Dvořák – svahové sekačky s.r.o. Pohled 277, 58221 Pohled, CZ  parts@spider-cz.com	Service Bulletin	Bulletin:	78
		Date:	02.05.2016
	Hydraulic pump fun cover for ILD02SG	Informative

New hydraulic pump fun cover for ILD02SG

SPIDER ILD02SG S/N 1914 – 1947; 1962; 1986 and higher (from 2259 fitted by the manufacture)

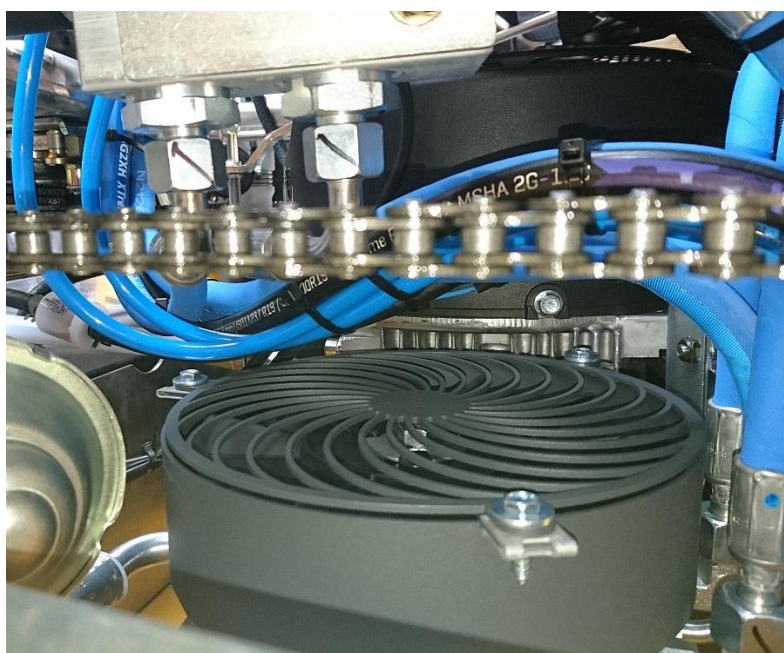
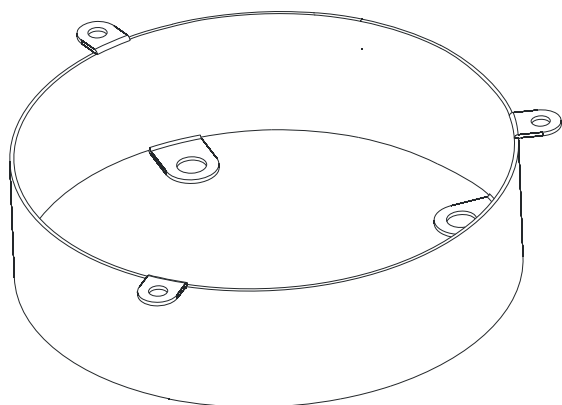
To increase the distance between new hydraulic hoses and the fan cover and avoid possible contact at the highest cutting position.

Because of the larger knee of new hydraulic hoses Gates the whole bundle of hydraulic hoses was closer to the fan cover of hydraulic pump on ILD02SG at the highest cutting position. To avoid possible contact with hoses the fan cover has been changed. The new fan cover is 5 mm lower and holes for attaching the grid are shifted. Only fan cover for Spider ILD02 has been changed. For Spider ILD01 stays the same as before.

<i>Affected parts</i>			<i>replacement parts</i>		
<i>Description</i>	<i>Number</i>	<i>Qty</i>	<i>Description</i>	<i>Number</i>	<i>Qty</i>
Fan cover ILD01+ILD02	1S02S200	1	Fan cover ILD02	2S02S200	1
